**BEFORE THE HEARINGS COMMISSIONERS
APPOINTED BY THE QUEENSTOWN LAKES DISTRICT COUNCIL**

IN THE MATTER of a submission on Te Pūtahi Ladies Mile
Variation to the Proposed District Plan

BY **LADIES MILE PET LODGE LIMITED**
Submitter

STATEMENT OF EVIDENCE OF ANDREW DAVID CARR

Figure 1: Extract from Ladies Mile Structure Plan (Annotated)

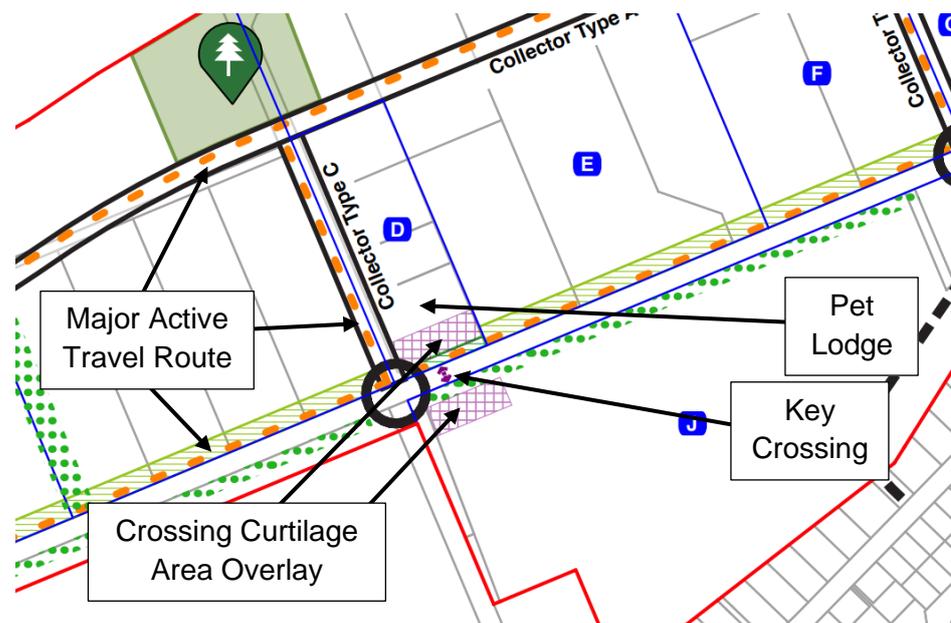
[13] It can be seen that the Crossing Curtilage Area Overlay occupies the full frontage of the southern part of Pet Lodge. The Key Crossing location is illustrated by purple arrows within the highway corridor, and this lies approximately 40m east of Howards Drive.

[14] On the immediate west of Pet Lodge is a proposed new road and a Major Active Travel Route. Major Active Travel Routes are also shown running along the full length of the northern side of the highway, although there is no provision shown on the southern side of the highway.

[15] Pet Lodge presently has an access located directly onto State Highway 6, located 85m east of the Howards Drive intersection (and therefore 45m from the Key Crossing Point). The current access lies within the proposed Crossing Curtilage Area Overlay.

Figure 2: Extract from Masterplan Transport Strategy ‘SH6 Proposed Bus Stops and Crossing Points’ (page 62)

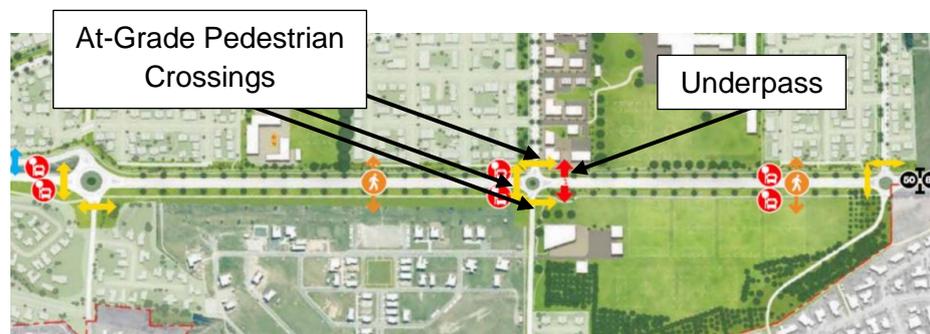
[21] Importantly it sets out the intent for “*signalised crossings of SH6 at its roundabouts with Stalker Road, Howards Drive and the new eastern roundabout to provide safe walking and cycling connections to the proposed bus stops and the proposed active travel improvements on Stalker Road and Howards Drive*”. The accompanying graphic shows signal controlled pedestrian/cycle crossings to the west of the Eastern Roundabout and west of the Stalker Road roundabout, as carried forward into the Variation provisions. It also shows the underpass, on the eastern side of Howards Drive. However the Variation does not mention the at-grade crossings that are shown to the north, west and south of the Howards Drive intersection, only the underpass.

- [38] Relocating the underpass towards the west would not appear to inconvenience users by introducing an additional road crossing. If the underpass was towards the east of Howards Drive, those users approaching from the west would need to cross the new road (Collector Type C) to reach the underpass. Similarly, a western underpass would mean that users approaching from the east would need to cross the new road (Collector Type C). In each case, there is an east-west flow across the Collector Type C road, and a signalised pedestrian crossing is already provided to accommodate this movement (as shown on Figure 2).

- [39] A similar scenario arises towards the south, where a proportion of users will inevitably have to cross Howards Drive, whether the underpass is located on the eastern or western side. Again, a signalised pedestrian crossing facility is provided (as shown on Figure 2).

than other crossing locations. However there appears to be no supporting technical argument that this is the case. The s 32 report shows five other pedestrian/cyclist crossing locations (indicated on Figure 2 above), which are spread out over the frontage of the Ladies Mile area. These provide multiple opportunities for crossing the highway and road users are not channelled towards the Key Crossing but instead are able to cross at the location that most suits for their journey. On the information presented, I can see no reason why demand for crossing at the Key Crossing would be considerably greater than in other locations.

Figure 3: Extract from Masterplan Transport Strategy 'Howards Drive Underpass LM Masterplan proposal' (Appendix D page 21) Annotated

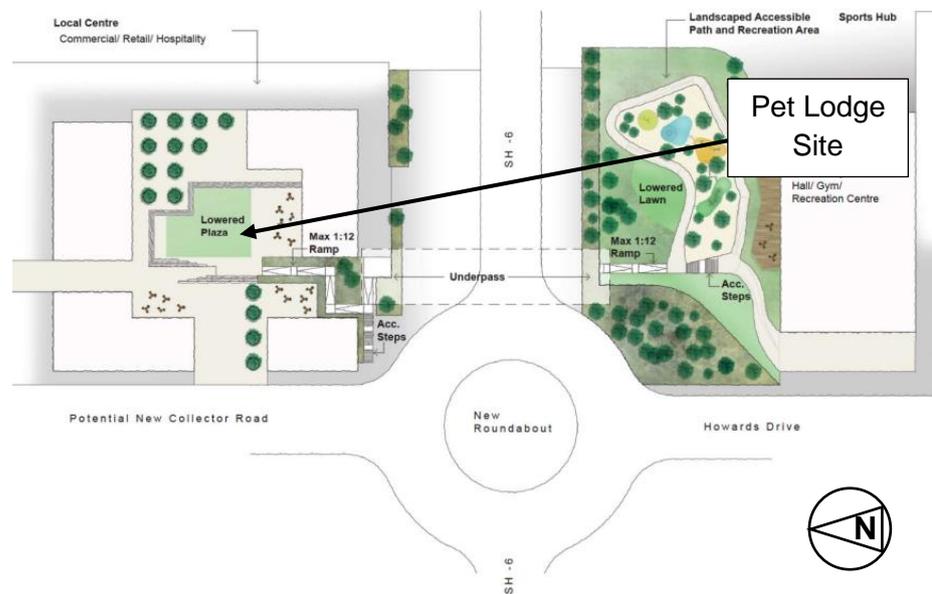
[24] Interestingly, this report also appears to show redevelopment of the Pet Lodge as part of the Ladies Mile Masterplan proposal.

[25] The text accompanying the graphic sets out that “*The ramp designs are incorporated into the Town Centre and the Community Hub masterplanning*”, notwithstanding that the northern ramp clearly penetrates into the Pet Lodge (by more than 12m). It goes on to say that an underpass located towards the west of Howards Drive was rejected because it did not provide a “*direct connection*” between the Ladies Mile Town Centre / High School and the Community / Sport Hubs and Lake Hayes Estate. No other reasons are given. For completeness I again note that this part of report reiterates the underpass is “*complemented*” by at-grade crossings of the highway.

- [35] Overall, it seems that the underpass location has been selected based on an assumption that Pet Lodge will disestablish or move elsewhere (as reflected in the report graphic replicated as Figure 3 above). It is only if the site is redeveloped that the desired design attributes for the underpass are achieved. I am unable to identify a scenario whereby the
